FCC Class II Permissive Change Request Letter

RE: FCC Permissive II Change Request for Company: Harman International Industries Incorporated

FCC ID: 2AHPN- HSA-20UT-AA

OBD Board :

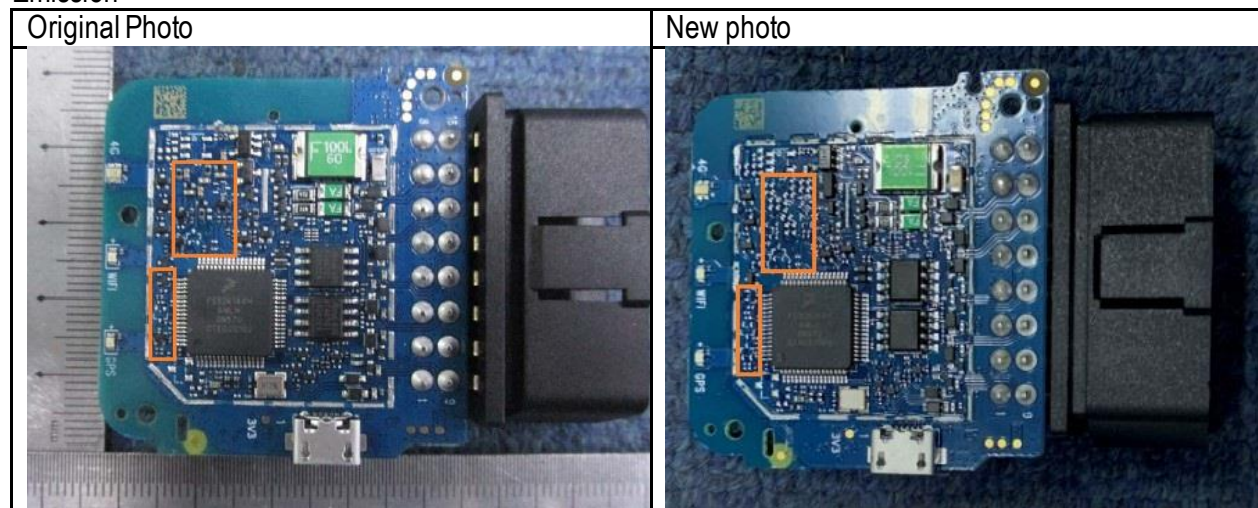
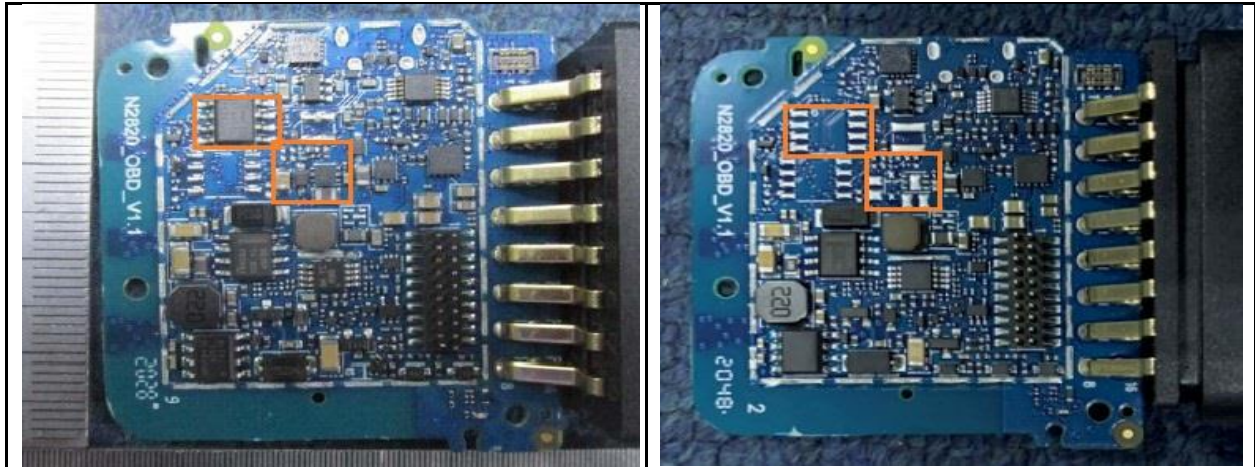
1. Remove 5 GPIO related devices : R170/R174/R178/R182/R222/R171/R175/R179/R183/R223/ R172/R176/R180/R184/R226/ R173/R177/R181/R194/R202/ U17/U18/U21/U23/U24/C102/C107/C108/C109/C110.
2. Remove related devices of CAN transceiver circuit corresponding to 1/9PIN : R24/R197/ R199/R206/ C104/ Q1/Q2/R26/R48/U20/ R211.
3. Remove GPIO and 12V power supply circuit related devices compatible with single line CAN : R168/ C99/ R145/ R140/ C100/ R141/ D9/ U5/ L5/ R103.

This change not impact the RF Parameters and we retest EMC Conducted Emission and Radiated Emission
